# Agenda Item #1

## Application 2025-05-CA

Construct a two-story single-family dwelling

DeTonti Square

SCALE: 3/16"=1'-0" SIDE ELEVATION

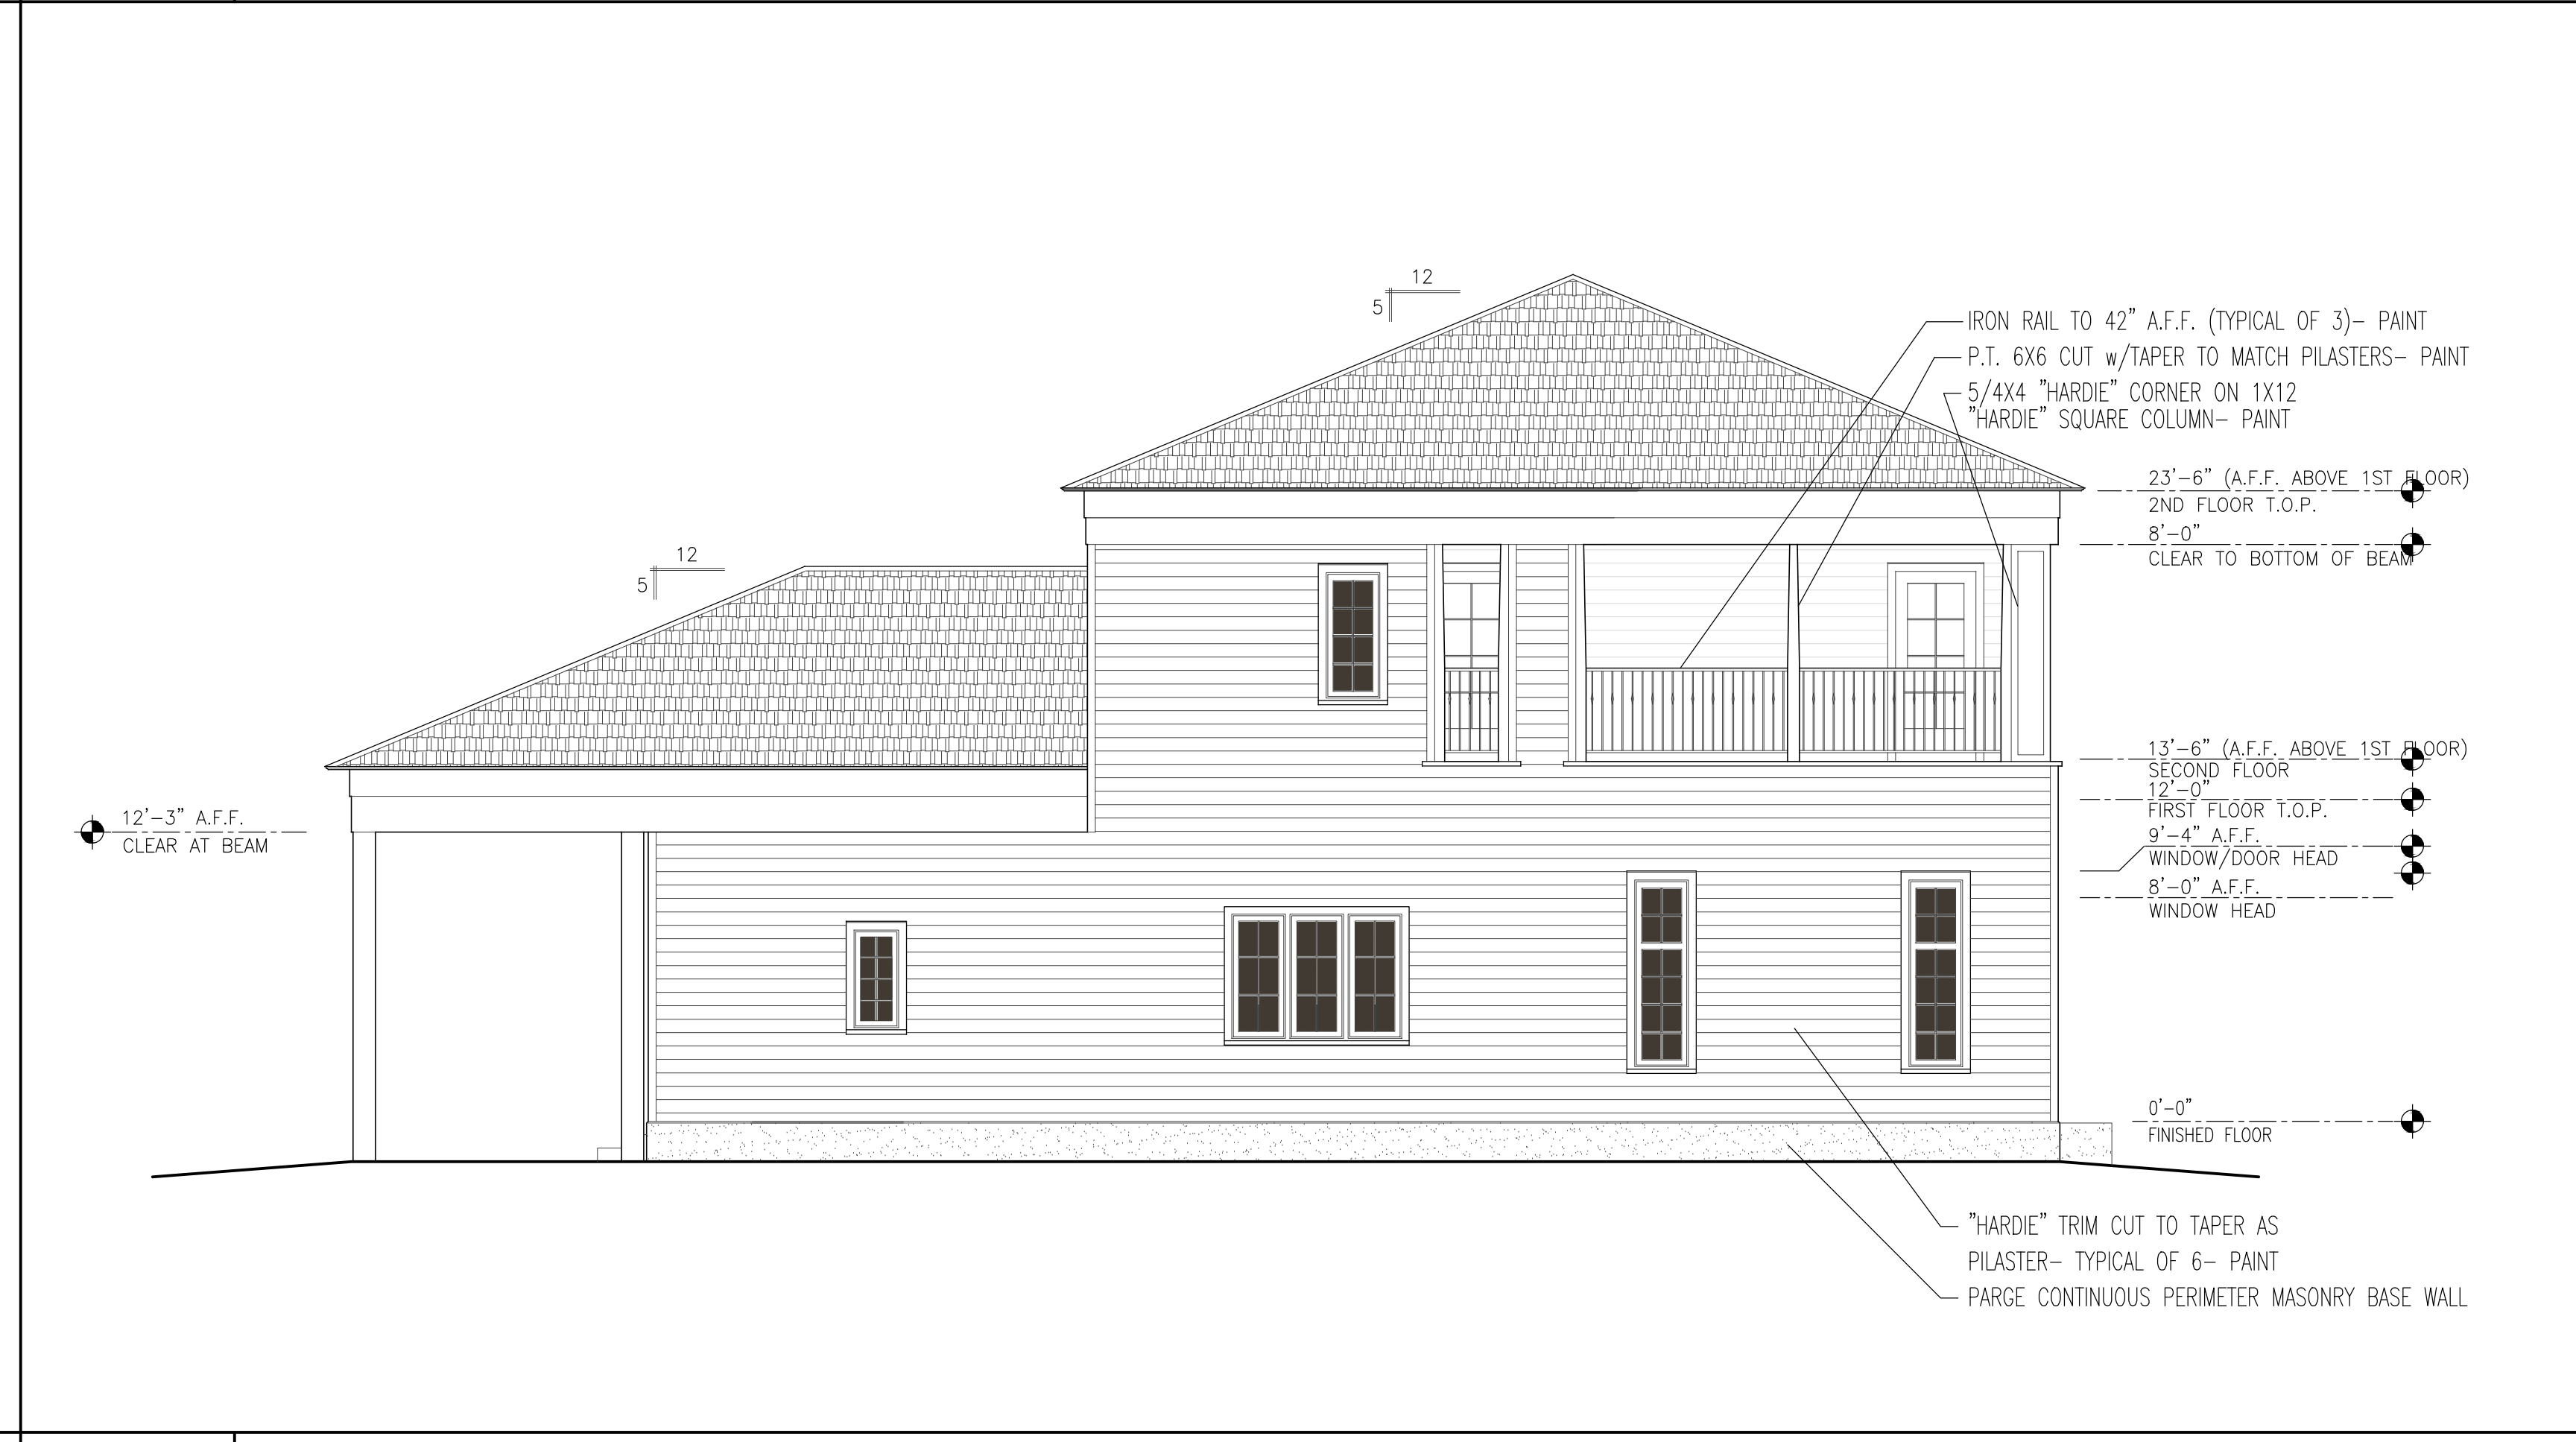
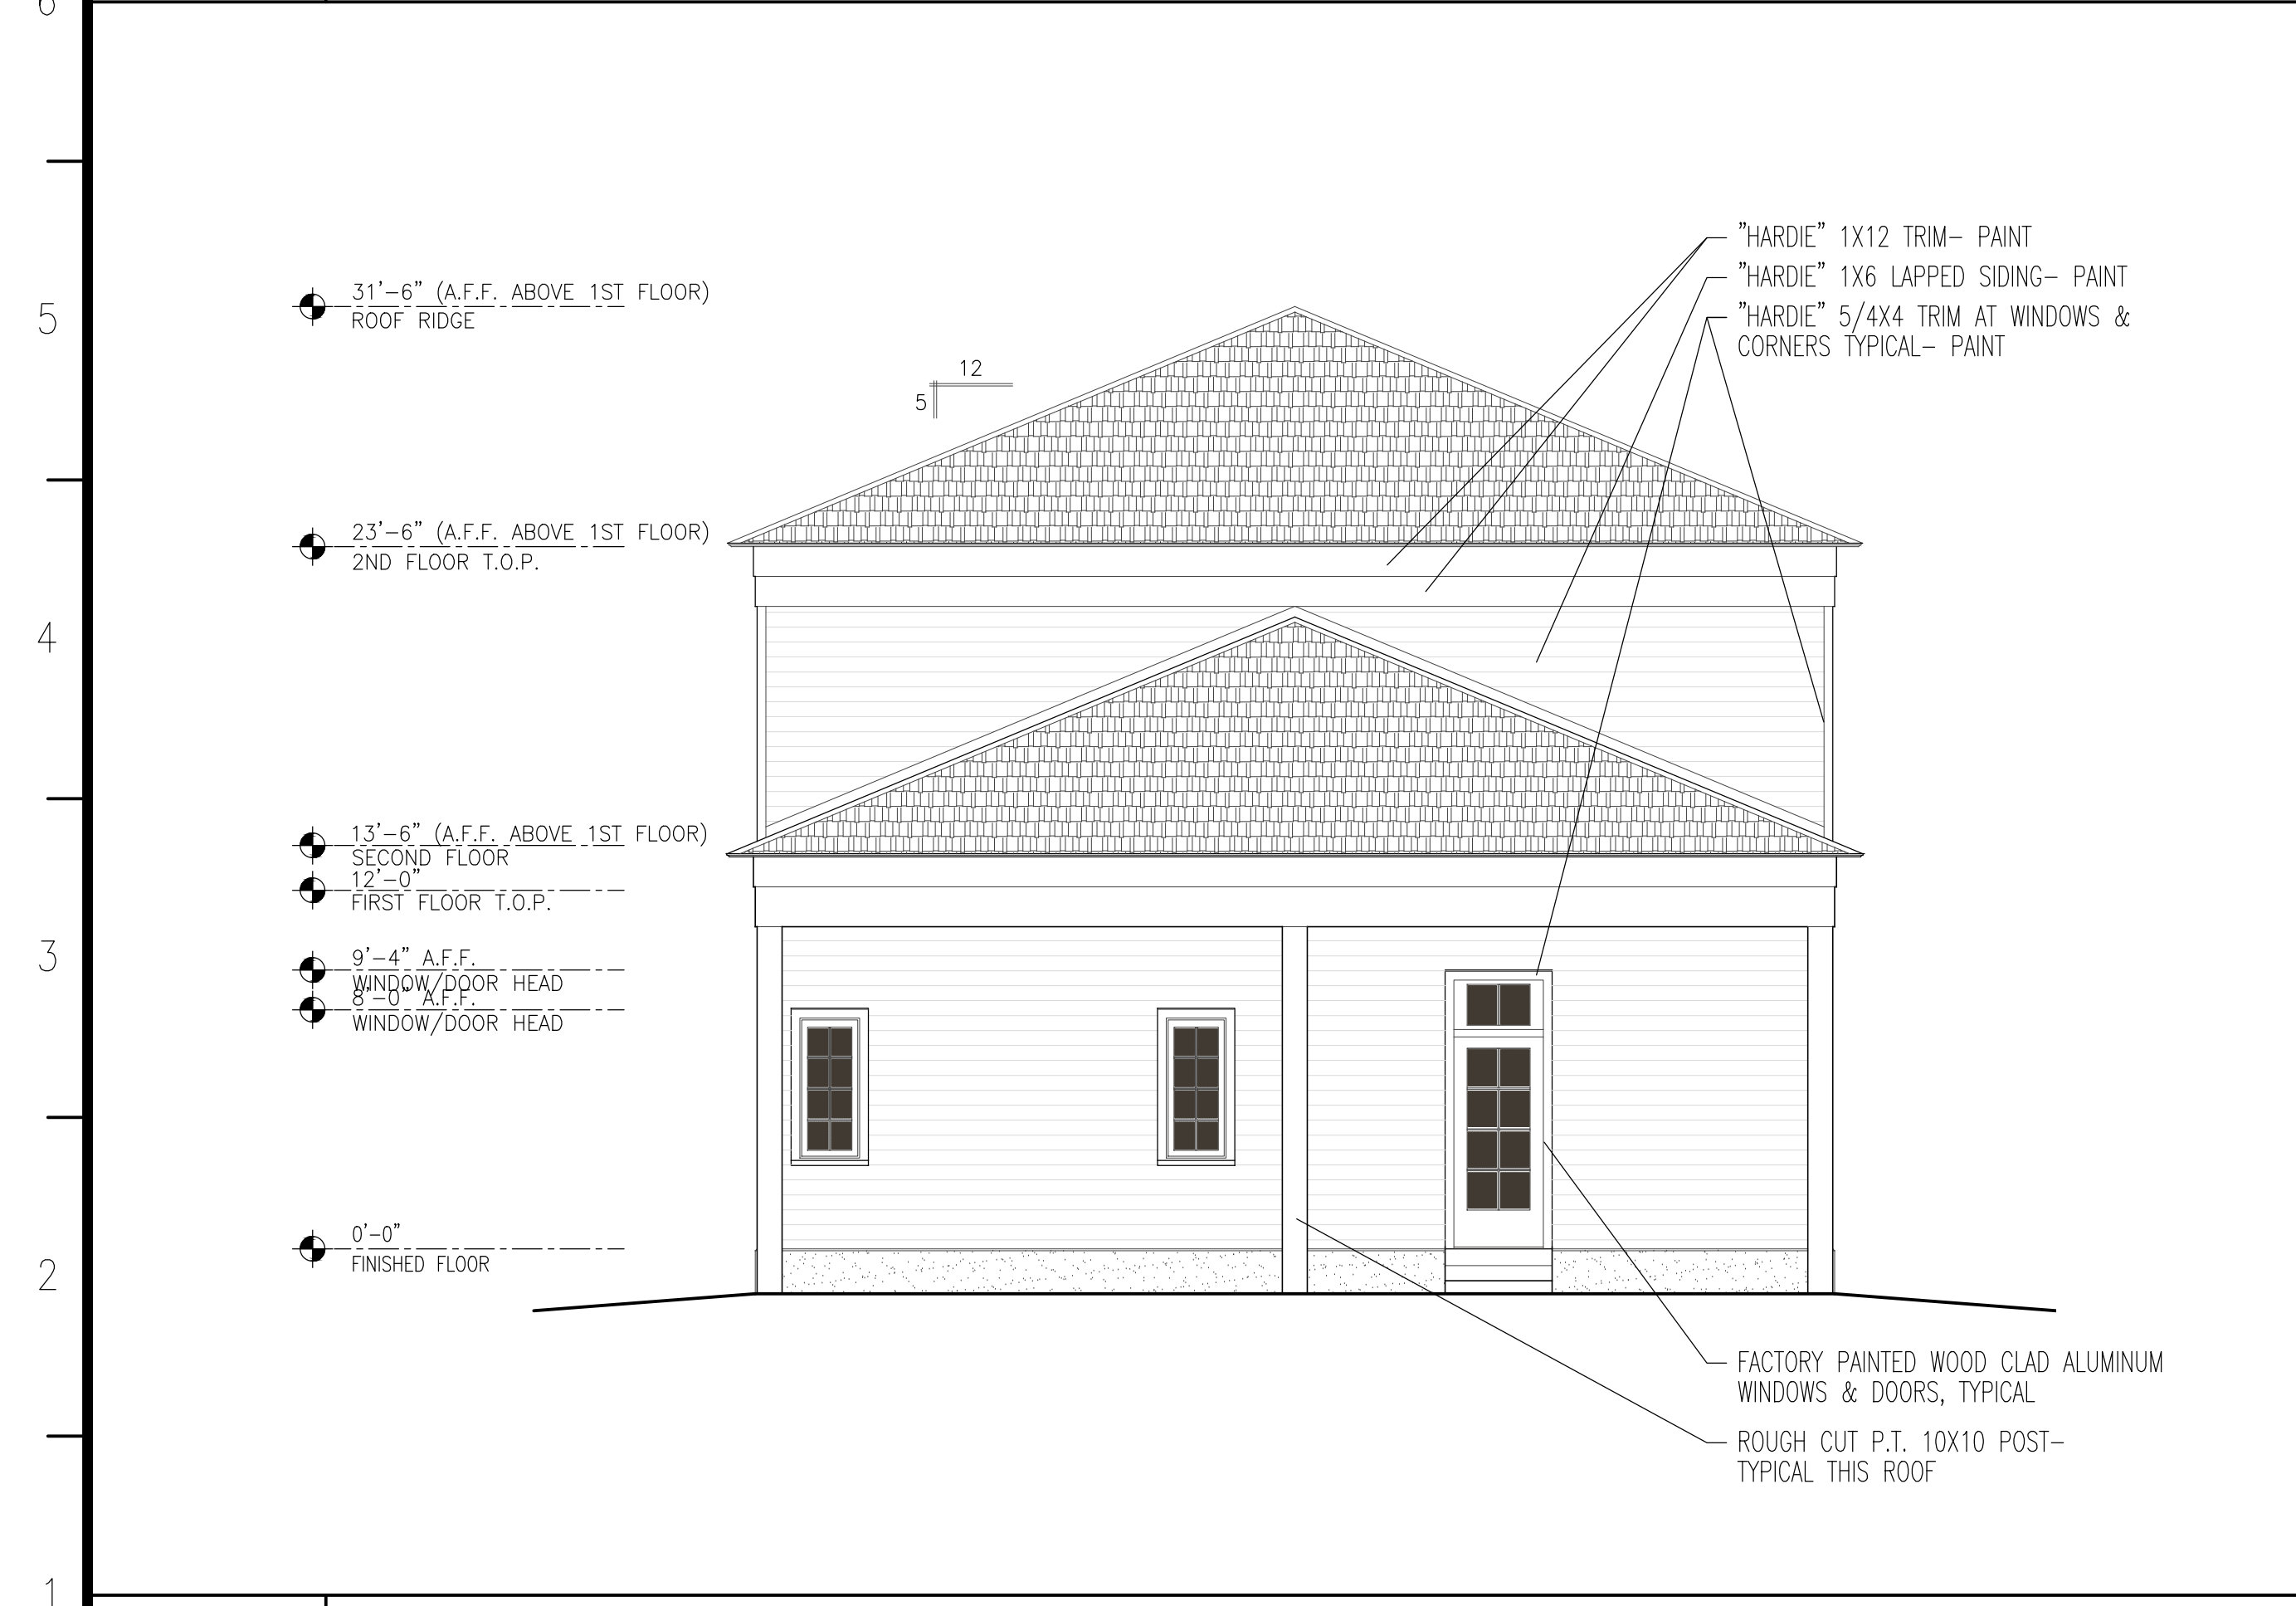
The *Guidelines* state that the scale of new construction should be compatible with those of surrounding historic structures along the street. The scale of the proposed structure is slightly larger than most historic buildings on the street (except for 310 N Claiborne) but does fall into a range that would be in keeping with many structures in the district at large. The scale of the proposed porch along the south elevation does not match the main building, or the scale of porches in the district, as outlined in the *Guidelines*. Similarly, the foundation does not appear to reflect the height of those of surrounding structures. (6.37, 6.43)

The submitted design does not achieve the *Guidelines'* objective of compatibility regarding massing. The large block form with hipped roof is out of step with dwellings across the street and those further afield in the district. The plans convey an attempt to break up the massing by introducing recesses and projections with the inset entry surround and the second-floor side porch. While these features could certainly produce a more compatible arrangement, as submitted, they do not read as fully developed nor serve to produce a cohesive design. Adjustments to these features could help to bring the plan into compatibility with the surrounding district. (6.36, 6.38, 6.44, 6.42)

The proposed hipped roof design echoes the roof structures of many historic buildings in the district. However, the most hipped roofs in DeTonti are of a lower slope that are not as visually evident. The scale, ratio, and pattern of the proposed fenestration on the exterior walls do not appropriately reflect the building traditions seen in DeTonti Square. On the façade, the second-floor windows above the recessed entrance seem too small for the space. The same is the case for the two stacked eight-light windows used on the stair hall's façade. The result of the various sizes communicates a lack of a distinct style and consistency. (6.38, 6.40, 6.45)

The building traditions in DeTonti Square predominantly emphasize rectangular design with offset wings that feature front or side galleries; there are more symmetrical examples with centered entryways, which are at times recessed and accentuated with classical trim. These styles most often consist of a flat or low-sloping hipped roofs (some with parapet walls). There are irregular forms common in DeTonti Square, with complex roof forms, wrapped porches, and cross gables. Fenestration is consistently proportional to the main building. As stated above, the plans depict an attempt to implement some of these elements, which could be modified to appropriately reflect the above building patterns.
